## Lower Thames Crossing

### Summary Review of Community Impacts Consultation

On behalf of **Thurrock Council**

Project Ref: 332510065 | Rev: C | Date: October 2021

Figure 2-1: LTC Conflict (or Opportunity) Points with Thurrock's Emerging Transport Vision to Support Sustainable Growth

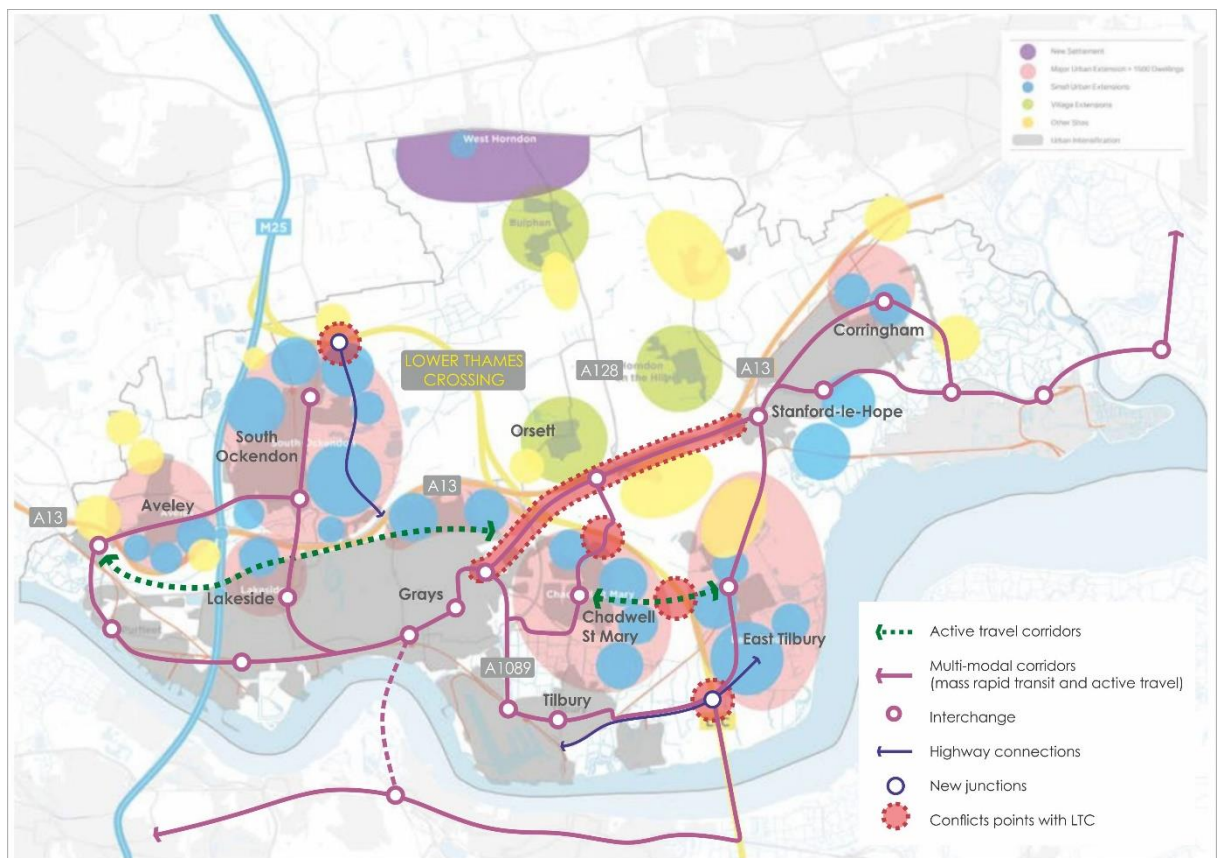
- 2.6.11 The Council's Issues and Option Stage 2 of the emerging Local Plan process has identified a number of possible growth areas. Those which are directly affected by LTC are: Tilbury, East Tilbury, Chadwell St Mary and South Ockendon. The LTC either severs or impacts access to the land available for the provision of homes and jobs in these locations, but there are opportunities to deliver improved connectivity which would help to facilitate this growth, and the Council have been seeking to ensure that these are considered, safeguarded and implemented. The opportunities that have been discussed with HE include:
- i. The provision of a junction and link at **Tilbury** for:

- a. Multi-modal access to the Tilbury Growth Area via Tilbury Link Road, and potentially Chadwell St Mary Growth Area.
- b. Multi-modal access to East Tilbury Growth Area.
- ii. Public transport access (if TLR not delivered early) and crossing of the LTC at **Brentwood Road** (Chadwell St Mary).
- iii. **A1013** bus priority.
- iv. A future junction at **South Ockendon**, to provide access to growth locations.

2.6.12 **Figure 2-1** below illustrates the primary opportunities for access of network enhancements in support of the delivery of growth in Thurrock.

Figure 2-2: Route 1 from M2 J1 to the Port of Tilbury

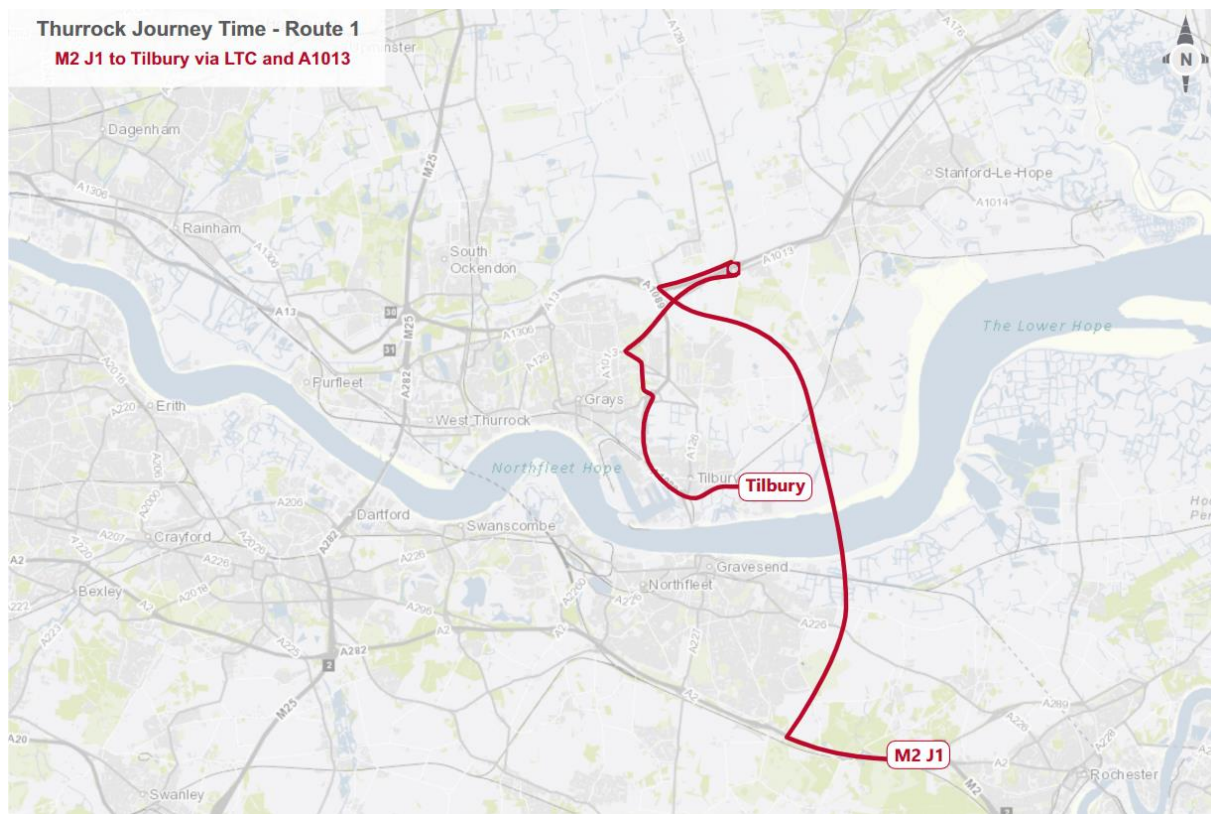
2.8.6 It is clear that access to the Port of Tilbury, once the LTC scheme is completed and operational, will be circuitous from the LTC north and southbound. The routes vary but in order to access the Port from LTC, traffic would need to go either via the Orsett Cock Roundabout (along the A1013 to Daneholes Roundabout, via Wood View and Marshfoot Road to join the A1089), through Chadwell St. Mary (along Brentwood Road, via Marshfoot Road to join the A1089), U-turning at Manorway Roundabout (back along the A13 to the A1089) or use the existing Dartford Crossing. Routes from M2 Junction 1 to Tilbury are shown in **Figures 2-2 to 2-4 below**.

- 2.8.7 The local A roads and unclassified roads/junctions are not designed to accommodate these increases in traffic and/or HGV traffic. There are safety, air quality and noise concerns relating to increasing traffic and HGVs, particularly related to the schools, residential dwellings, and local bus services along these routes.
